165 Park Ave.

Sea Dogs Clubhouse

HADLOCK STADIUM AMENDED SITE PLAN

HADLOCK FIELD STADIUM AMENDED SITE PLAN

PROPOSED GRADING PLAN

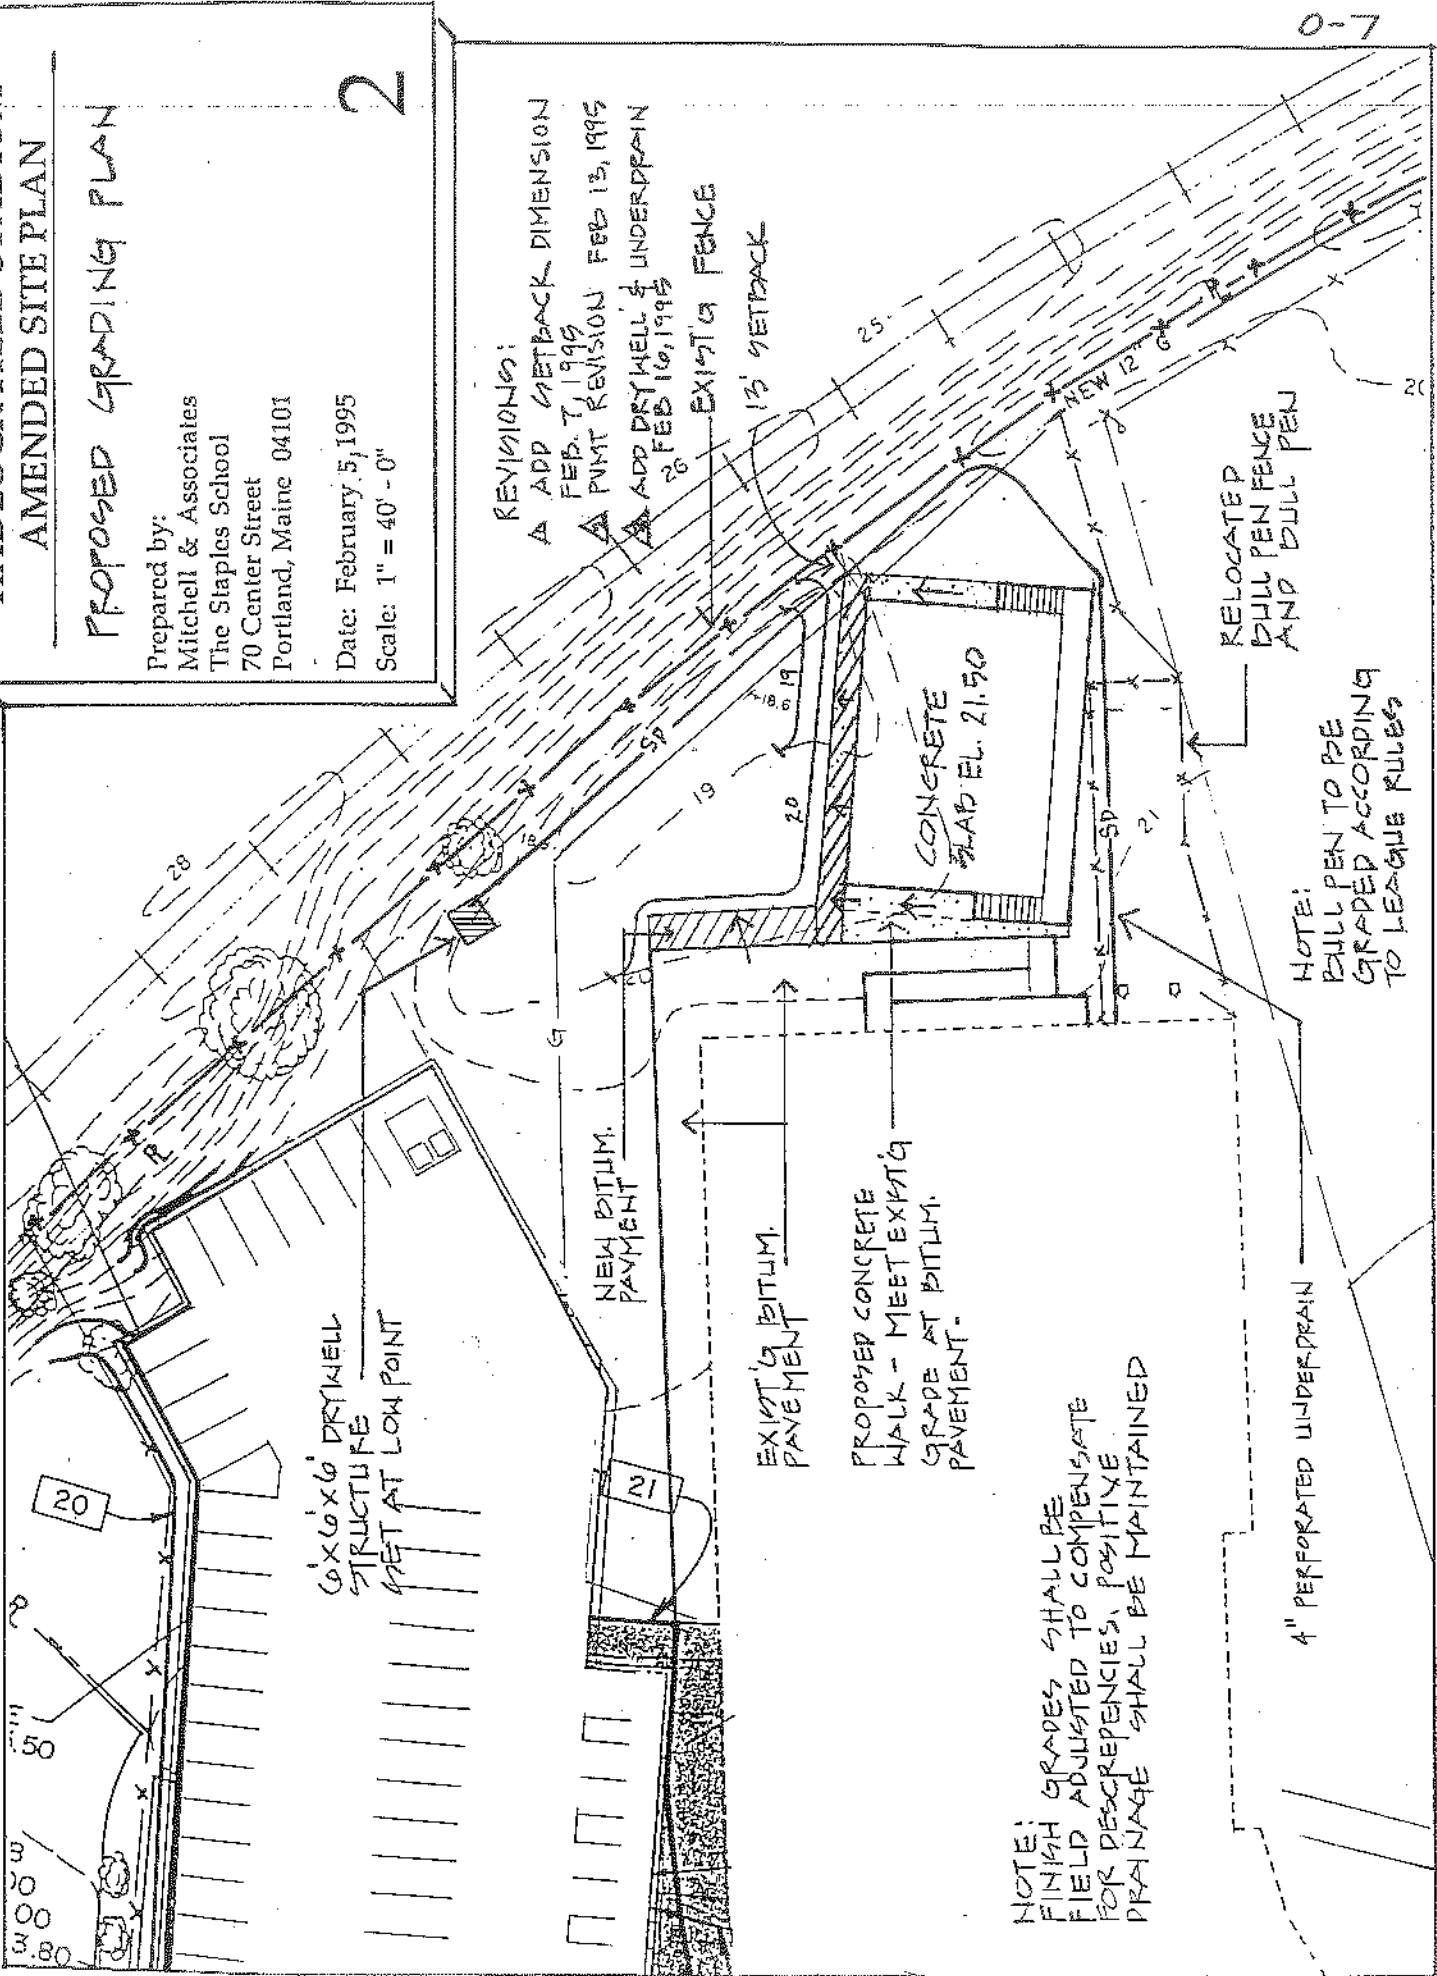
This submission is in response to our meeting at the site on Wednesday February 15th where we discussed the issues concerning stormwater management. At that meeting it was agreed to provide a dry well structure at the low point near the existing access gate to the proposed bleacher area. A six foot diameter by six foot deep dry well will be excavated and filled with one inch crushed rock, topped with a geotextile fabric and four inches of loam. The finished grade will be pitched toward this low point. In addition a four inch diameter perforated PVC underdrain will be installed along the front of the new bleachers and connect to the proposed dry well.

Based upon discussions with the Planning Department and their consulting review engineer, a dry well shall be constructed at the designated low point as shown on the Amended Site Plan. In addition, a four inch perforated underdrain shall be installed to aid in draining the relocated bull pen area. The underdrain shall be connected to the drywell.

- A ADD SETBACK DIMENSION FEB. 7, 1995
- Δ PUNT REVISION FEB 13, 1995
- ▲ ADD DRYWELL & UNDERDRAIN FEB 16, 1995

HADLOCK FIELD STADIUM AMENDED SITE PLAN

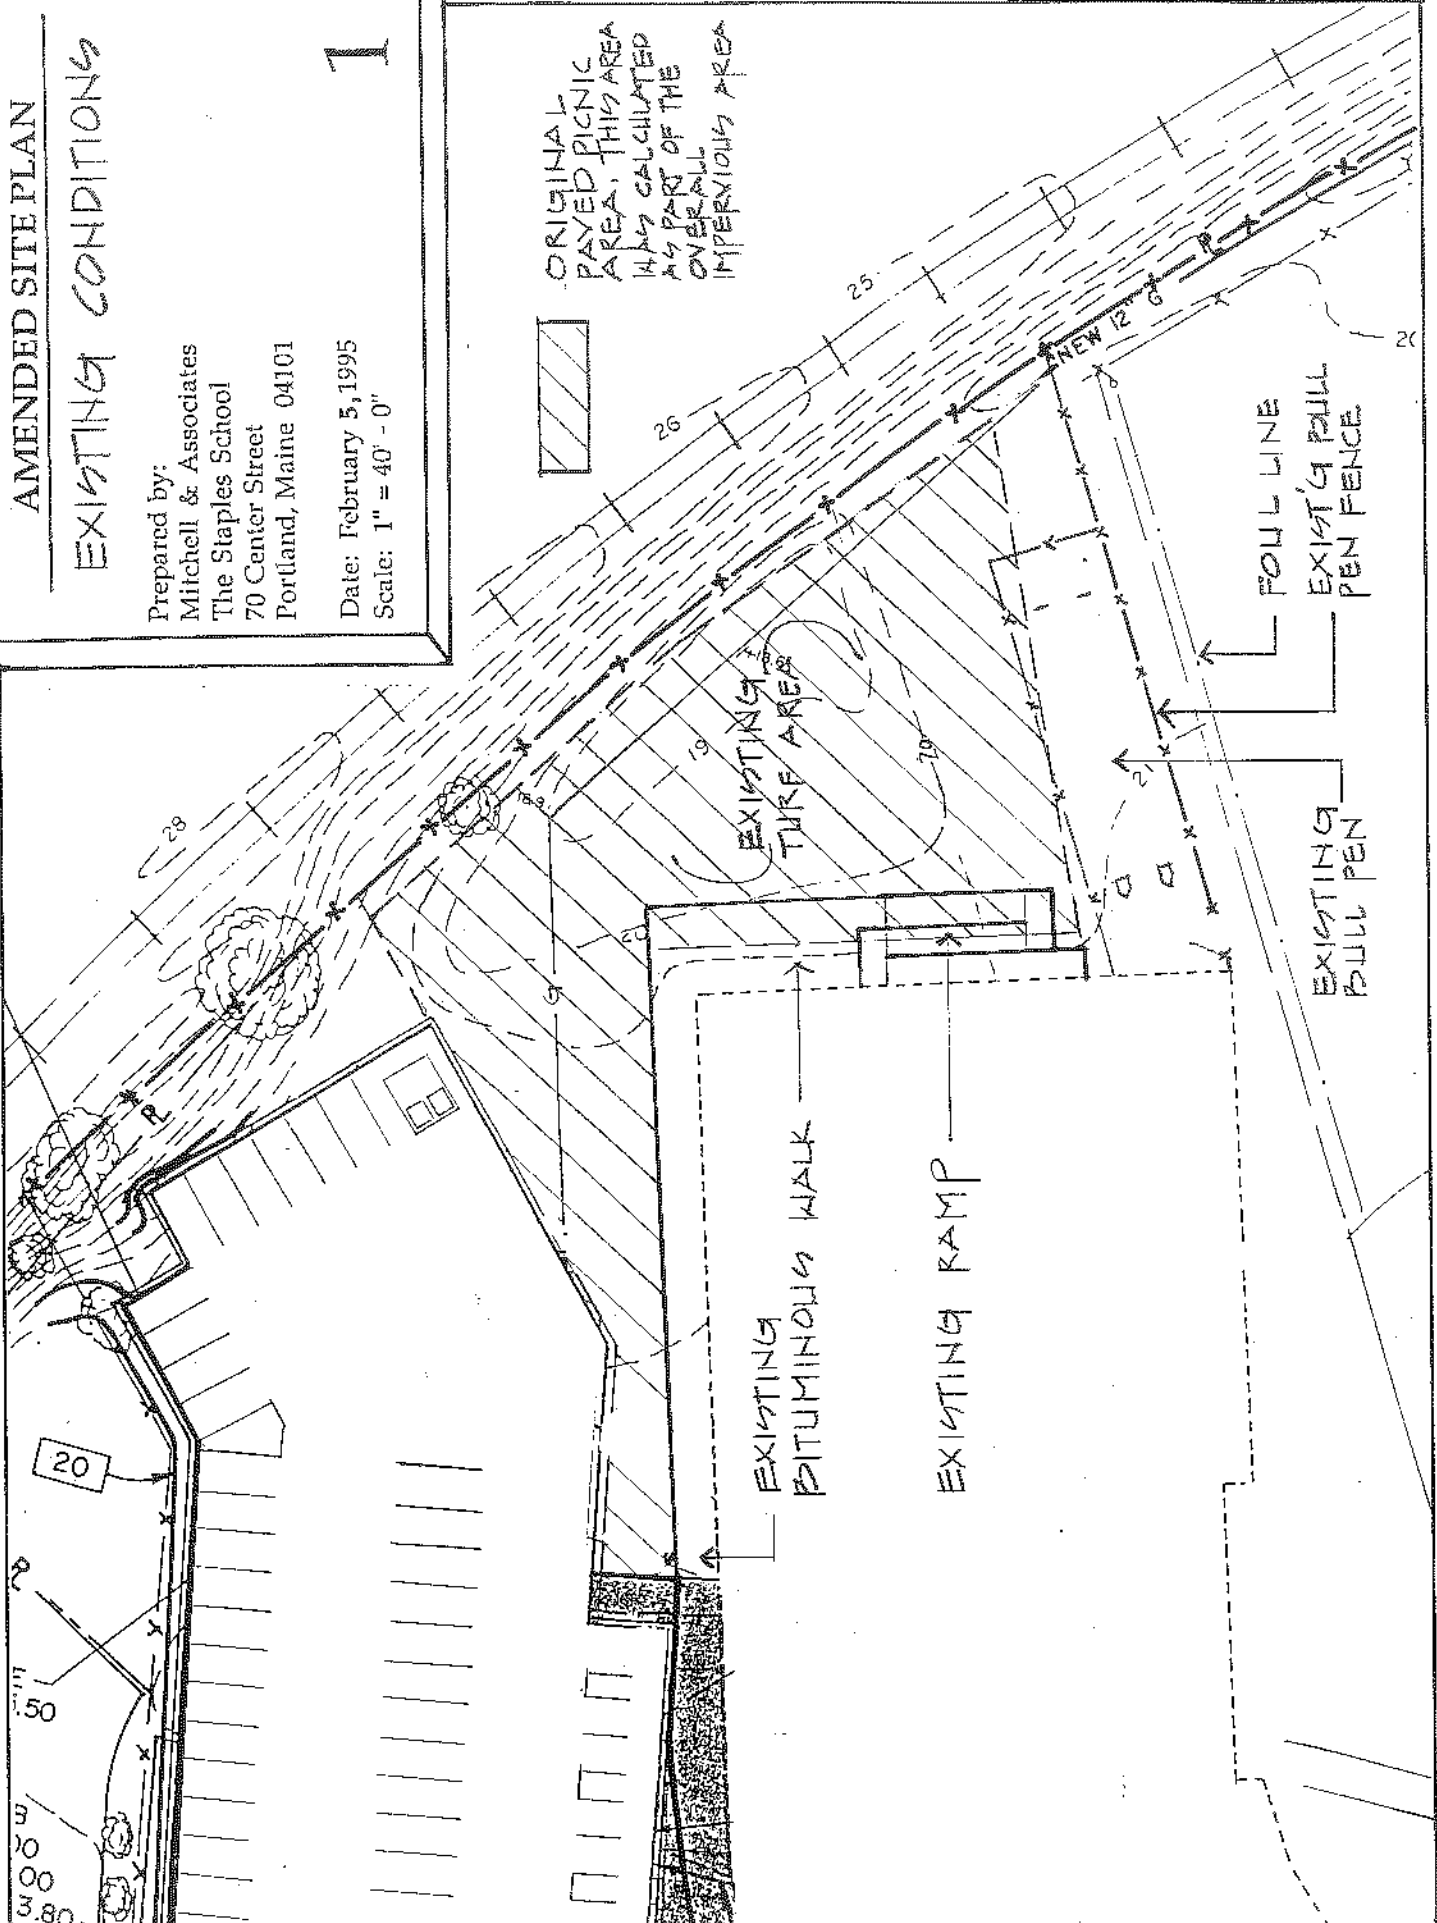
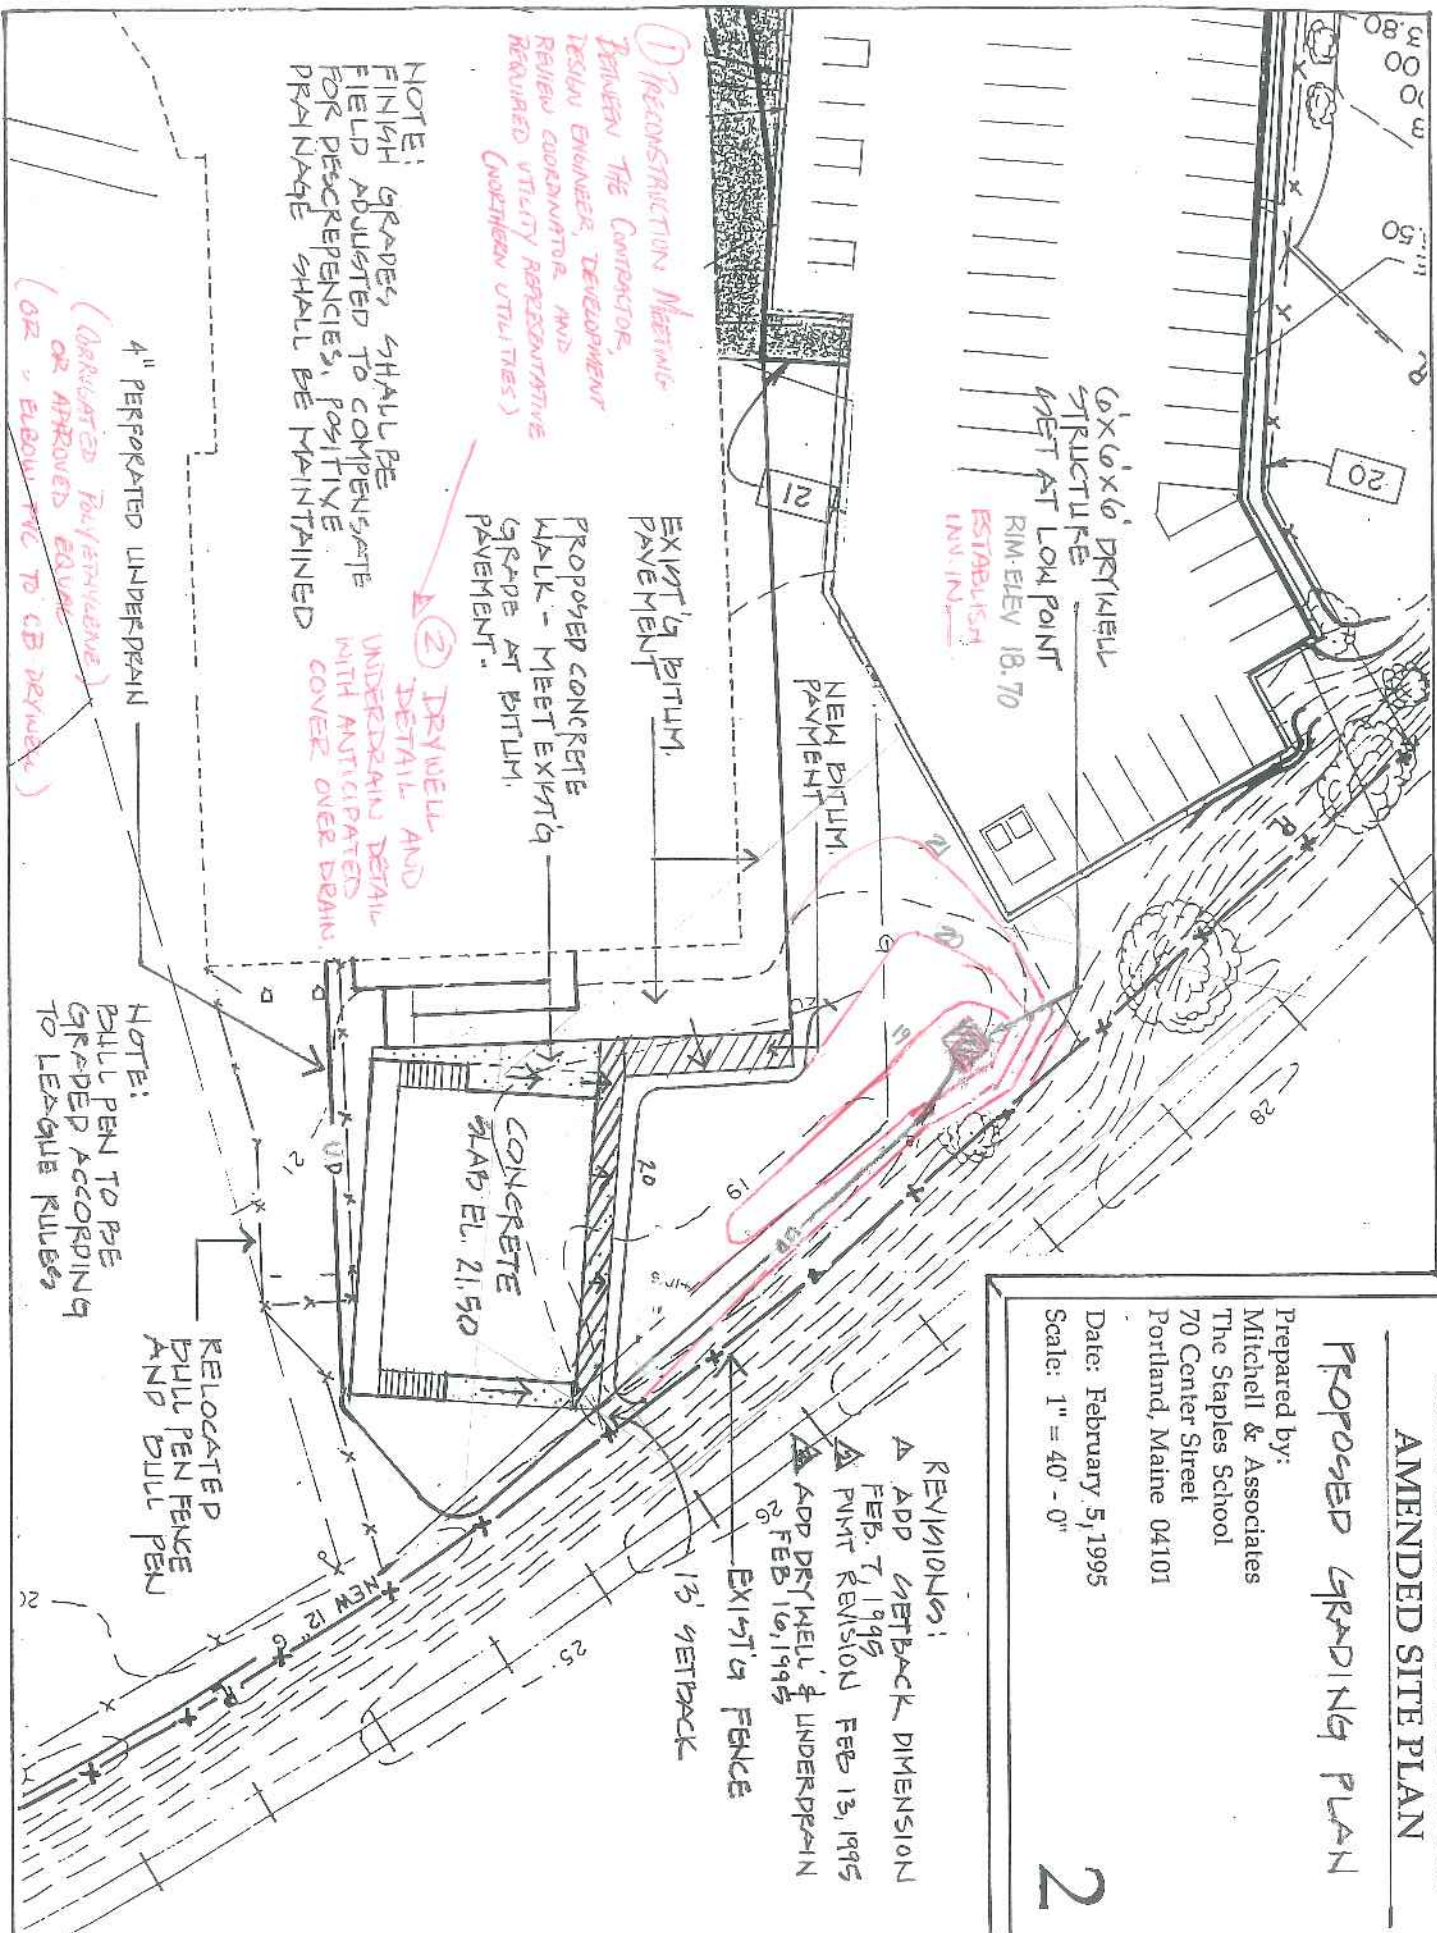
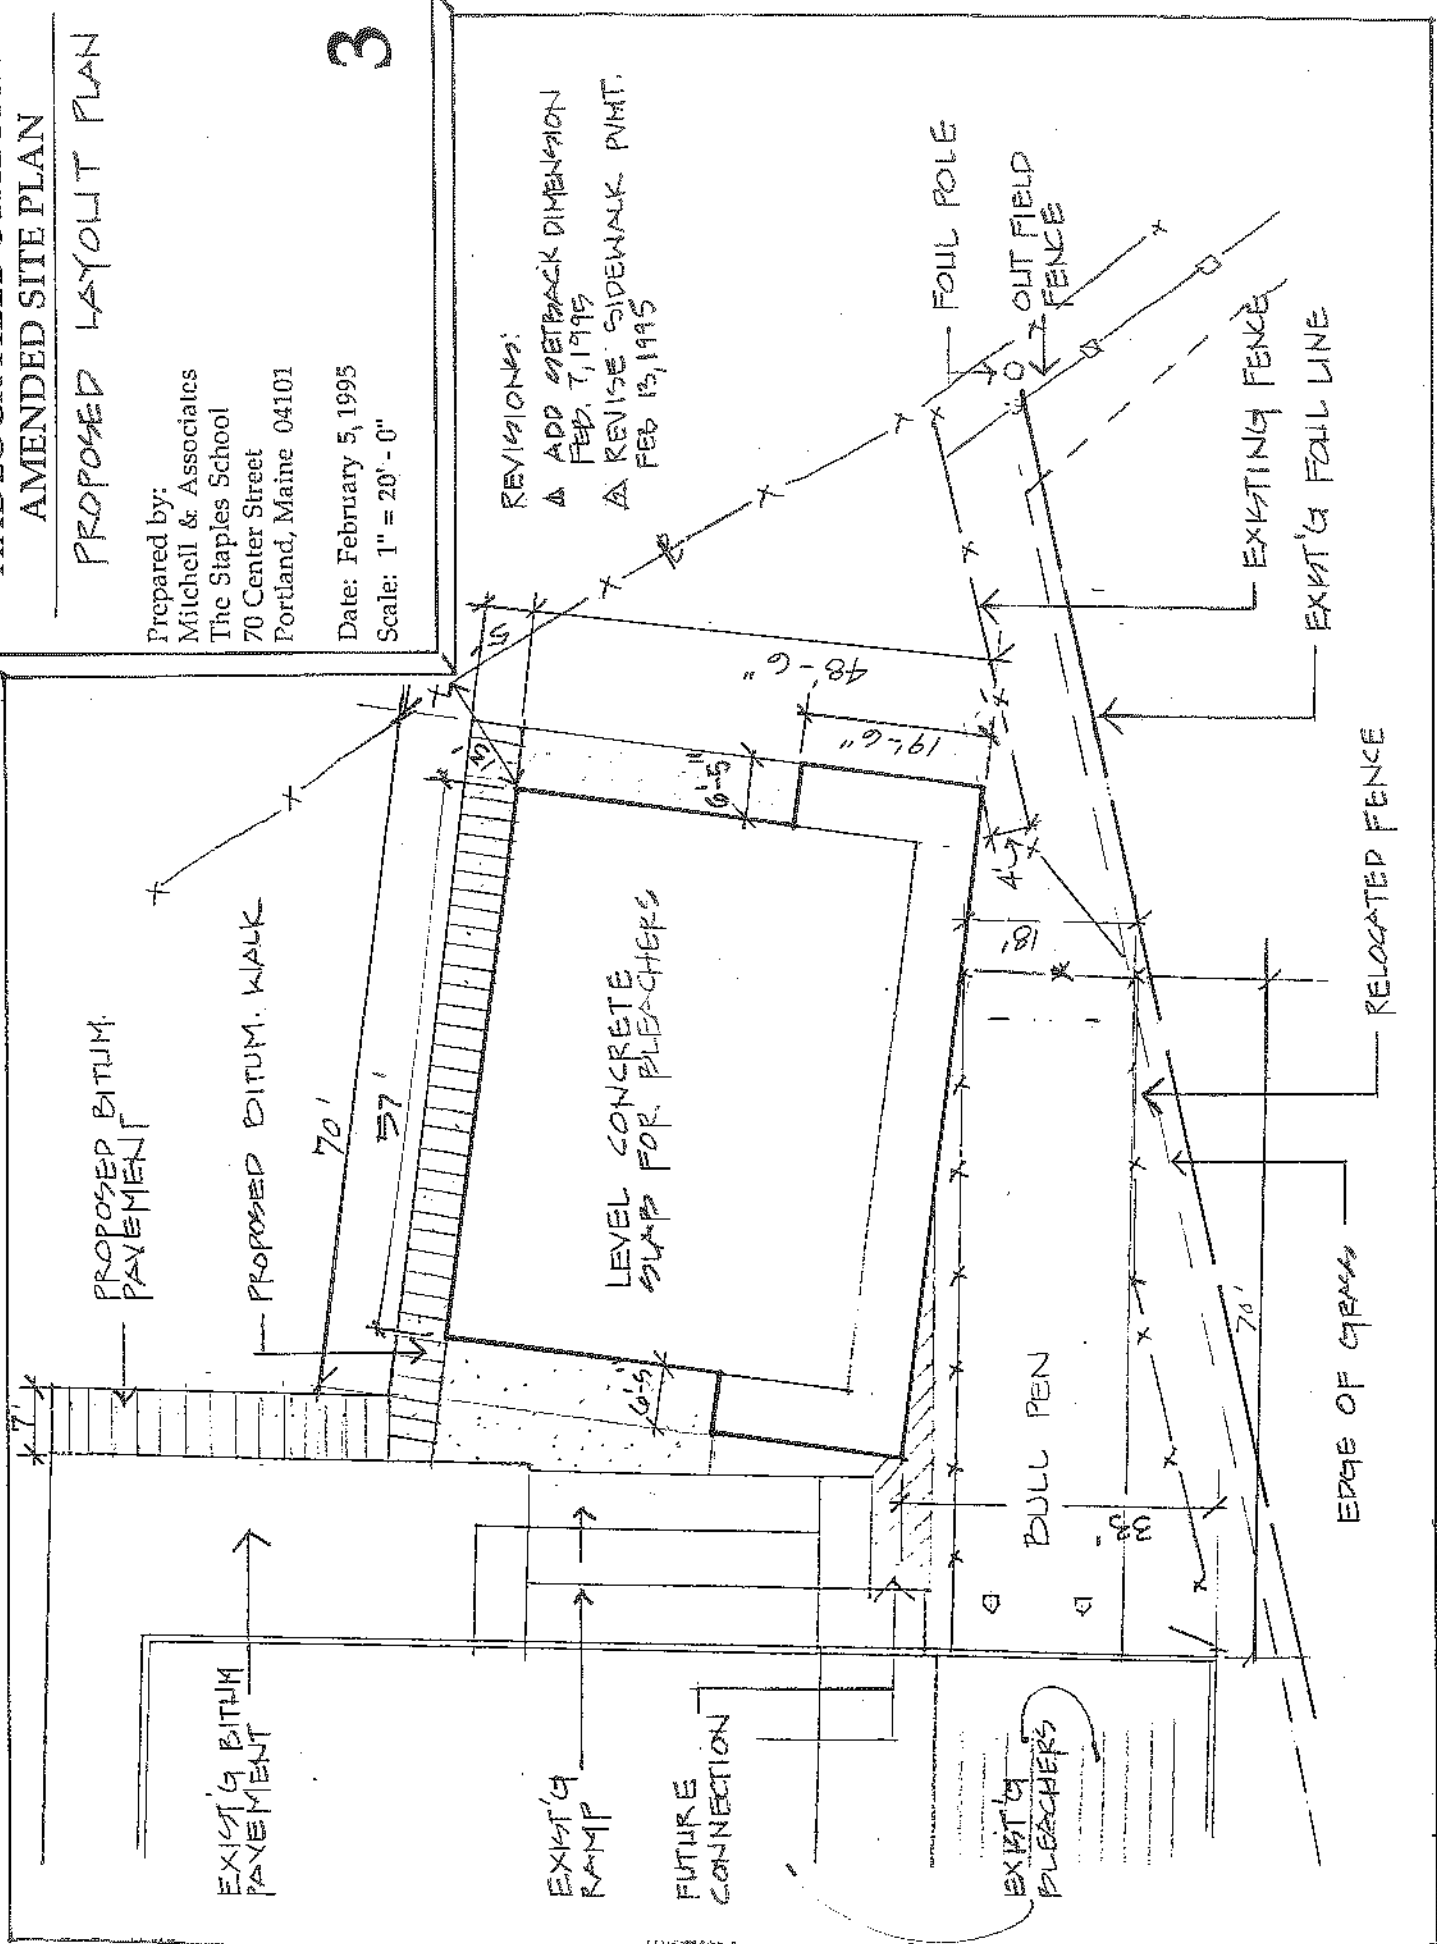
RIK,
SEE SHEET 2 FOR MY
COMMENTS AND SUGGESTED GRADING
WE MAY NEED MORE STONE TO CREATE
MORE VOIDS AND IN TURN VOLUME FOR
STORAGE. PLEASE HAVE THEM SUBMIT
A DRY WELL DETAIL!
Jim
